The Honorable Michael Regan
Administrator, U.S. Environmental Protection Agency
1200 Pennsylvania Avenue, N.W.
Washington, DC 20460
ATTN: Docket No. EPA-R06-OAR-2021-0801

Re: Arkansas Division of Environmental Quality Comments
Docket No. EPA-R06-OAR-2021-0801

Arkansas State Implementation Plan Revision: 2015 Ozone National Ambient Air Quality
Standard–Interstate Transport

Figure 1: Historical NOx Emission Data for Honeywell International

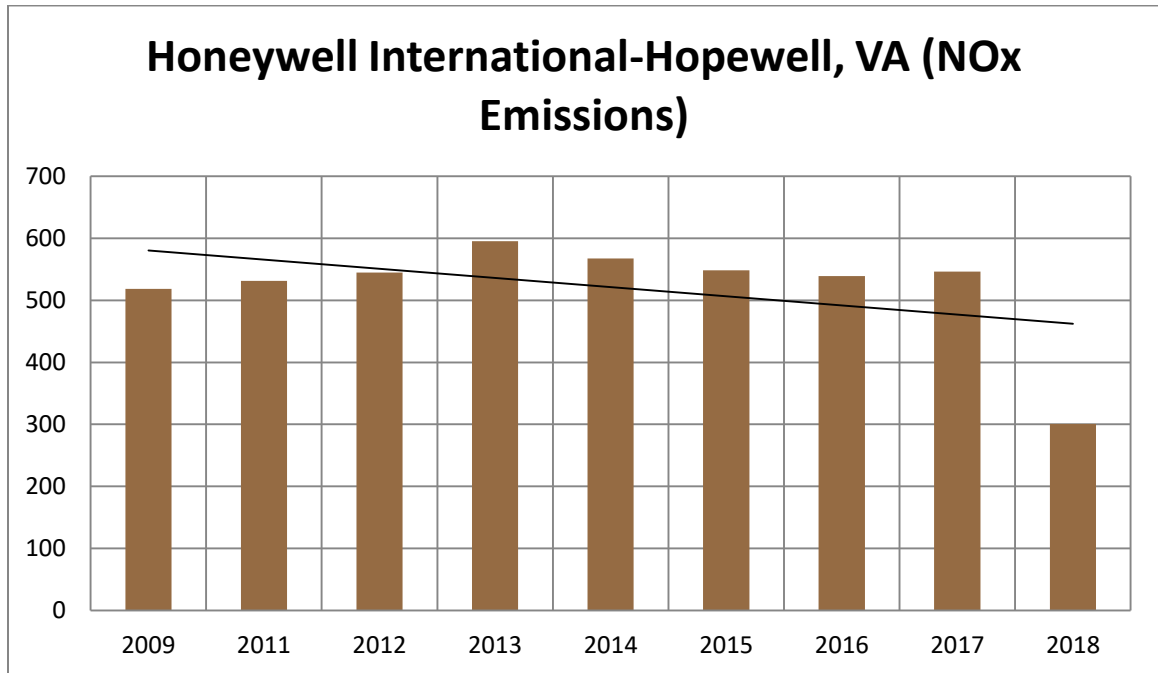
4. The future year projection factor for NOx emissions from "Honeywell International Inc. – Hopewell" (unit# 20375813) in Virginia is 6.79 for 2026 in the 2016v2 platform and was 0.63 for 2028 in 2016v1 platform. DEQ conducted trend analyses to evaluate some future year projection factors and DEQ's analysis for this source does not appear to support a future year projection factor of 6.79 and may support a future year projection factor of 0.62; however, Virginia may have suggested the 6.79 as the appropriate value and, if so, would likely be the best source of this data. DEQ suggests that EPA verify the above example, possibly with Virginia if data was not already provided by Virginia, and other similar examples.

Figure 2: Historical Emissions from John W. Turk Power Plant, AR

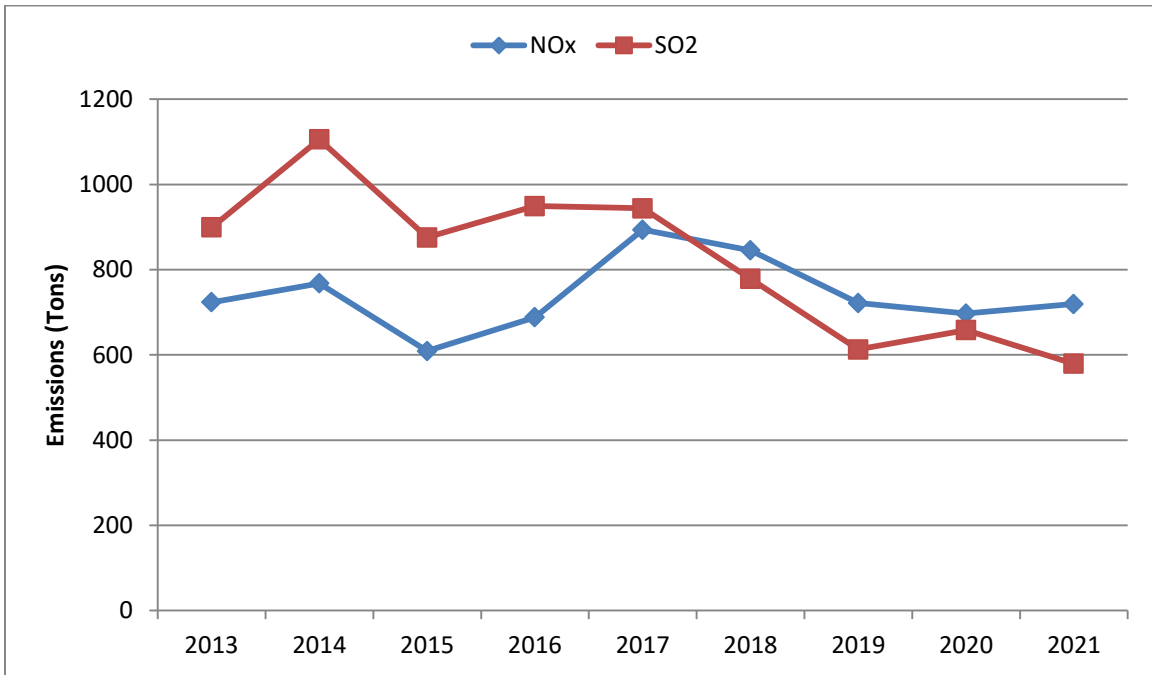
8. IPM did not project 2026 and 2032 ptegu sector emissions for the John W. Turk Power Plant. However, IPM did project 2026 and 2032 ptnonipm sector emissions for this facility of NOx at less than 1 ton and SO₂ at less than 1 ton. Historical NOx and SO₂ emissions for the John W. Turk Power Plant are presented in Figure 2. EPA should include appropriate 2026 and 2032 ptegu sector emissions and verify the 2026 and 2032 ptnonipm sector emissions for the John W. Turk Power Plant.

Figure 3: Historical Emissions from Plum Point Energy Station, AR

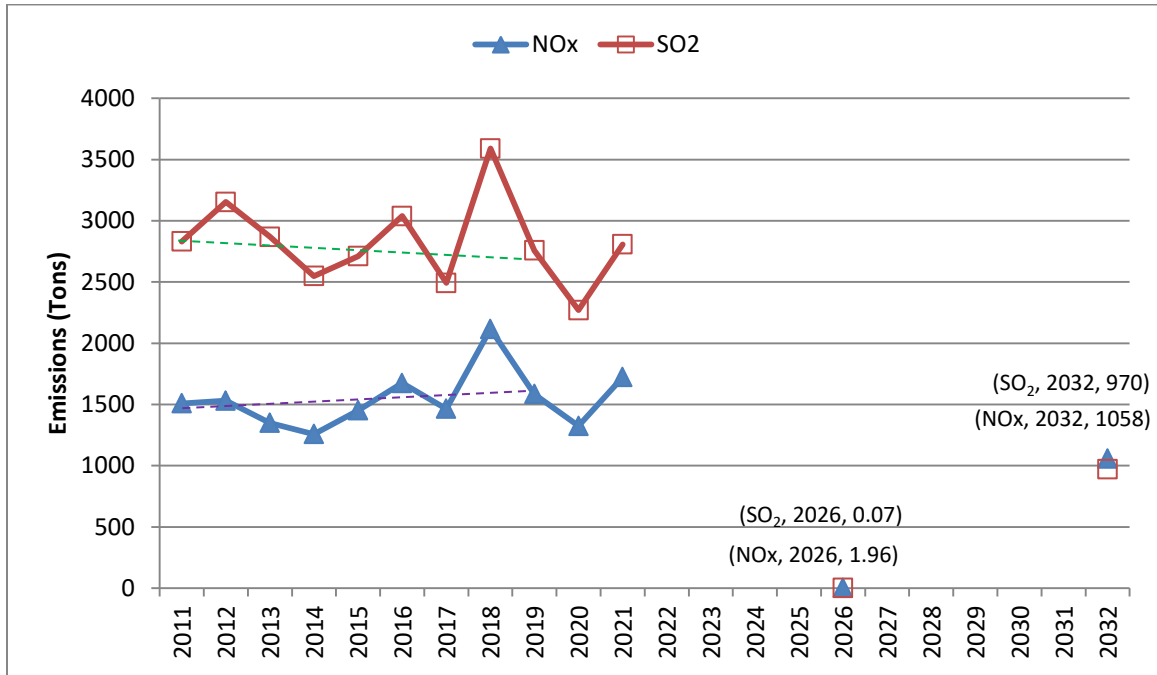
9. IPM did not project 2026 ptegu sector emissions for the Plum Point Energy Station. However, IPM did project 2026 ptnonipm sector for this facility of NO_x at 1.96 tons and SO₂ at 0.07 ton. Historical emissions for the Plum Point Energy Station are presented in Figure 3. In addition, IPM did project 2032 ptegu emissions, although the 2032 ptegu future year projection was a 62% reduction for SO₂ emissions from a 2021 baseline. For the Plum Point Energy Station, EPA should include appropriate 2026 ptegu sector emissions, verify the 2026 ptnonipm sector emissions, and verify the reasonableness of the 2032 ptegu SO₂ emissions.

Figure 4: Historical Emissions from Oswald Generating Station

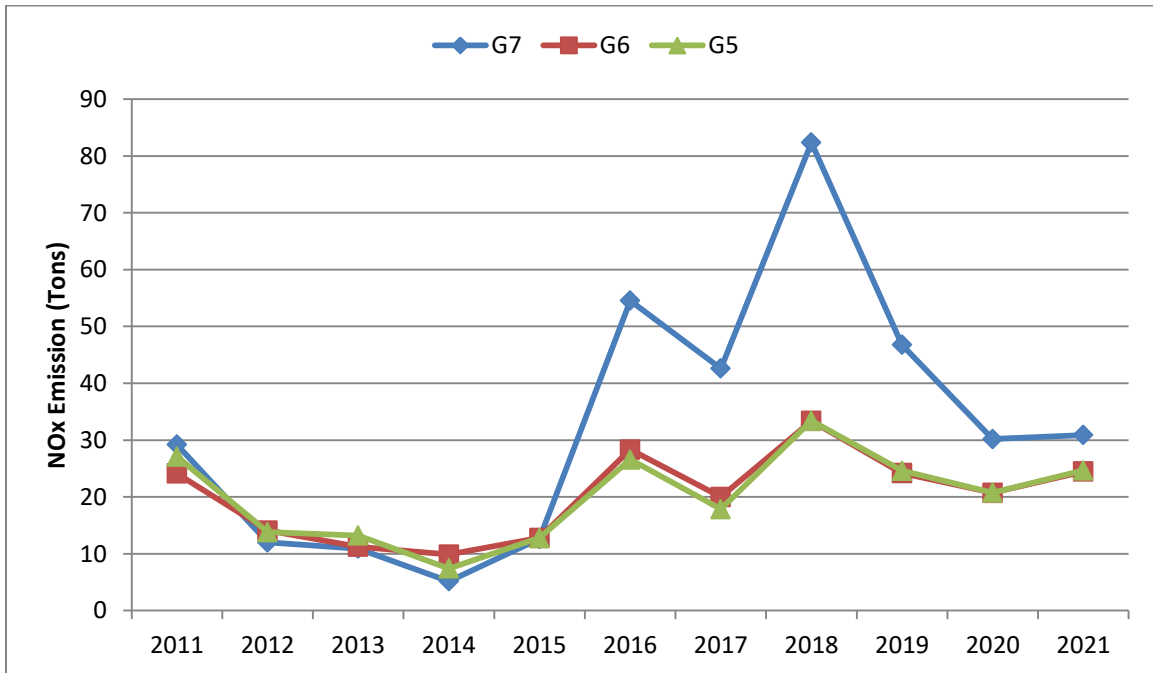
10. IPM 2026 projected NOx emissions from the ARK Elec Co-Op-Oswald Generating Station are Unit G7: 172 tons, Unit G6: 115 tons, and Unit G5: 115 tons. IPM 2032 projected NOx emissions are Unit G7: 160 tons, Unit G6: 107 tons, and Unit G5: 107 tons. Table 1 provides gross load from IPM future year projections and a 5-year average of historical data (2017-2021) for these units. The 2011-2021 historical NOx emissions for these units are provided in Figure 4. EPA should verify the reasonableness of projected 2026 and 2032 NOx emissions for all of this facility’s units and potentially for IPM-projected emissions at other facilities.

Figure 5: Modeled Contributions from All Linked States to Harris County, TX monitor (482010055)

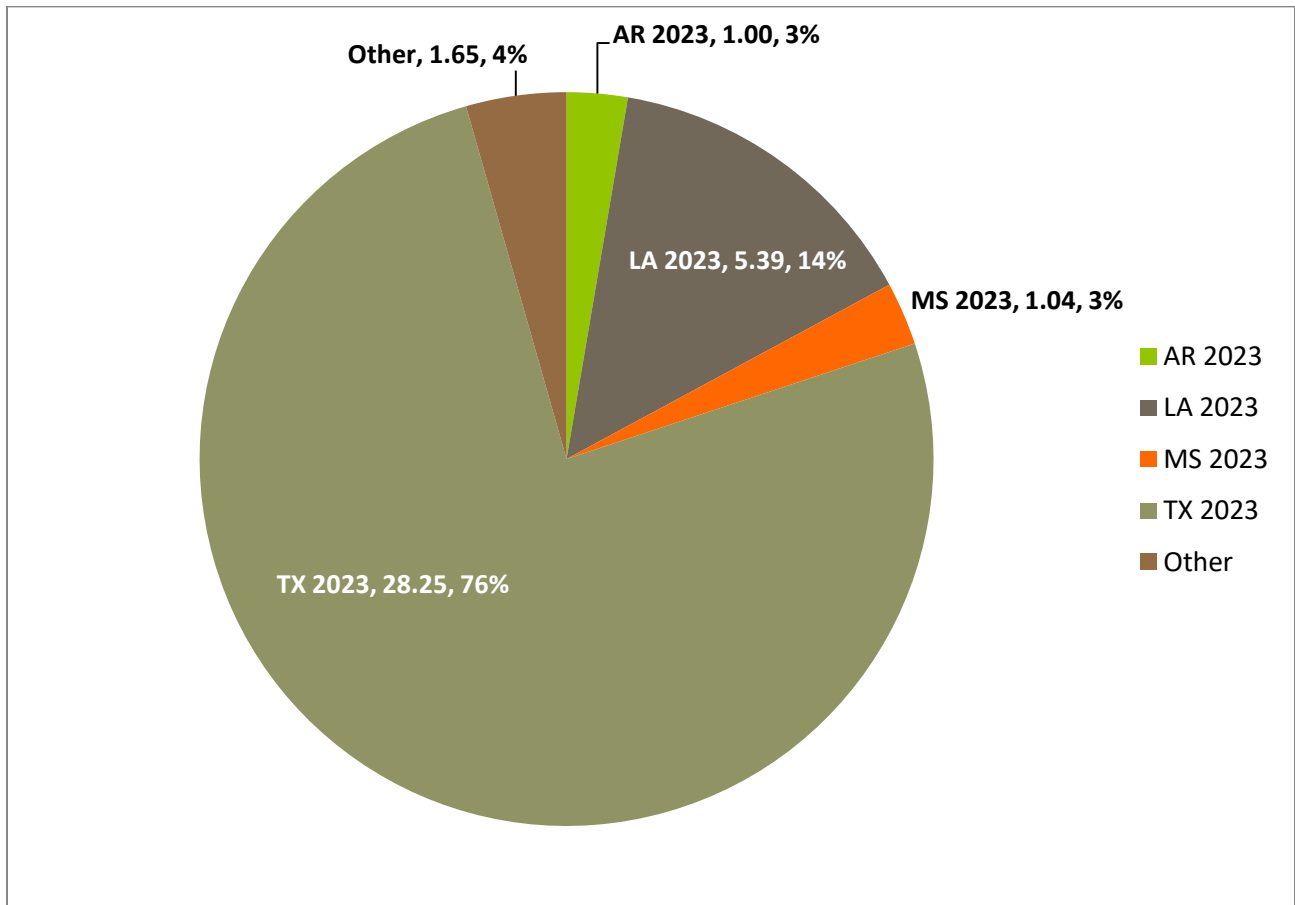
As a snapshot illustration of this point, Arkansas's linked contribution to the Harris County nonattainment monitor is modeled at 1.00 ppb. The modeled contribution from Texas is 28.25 ppb, more than 28 times the contribution from Arkansas, and Louisiana's contribution is 5.39 ppb, more than 5 times the contribution from Arkansas (see Figure 5). When contributions from international, offshore, initial and boundary conditions, fires, and biogenics are included, Arkansas's contribution falls to 1% of total contributions at the Harris County monitor (see Figure 6). Figures 5 and 6 illustrate the relative contributions from all linked states and the relative contributions from all states as well as international, offshore, initial and boundary conditions, fires, and biogenics.
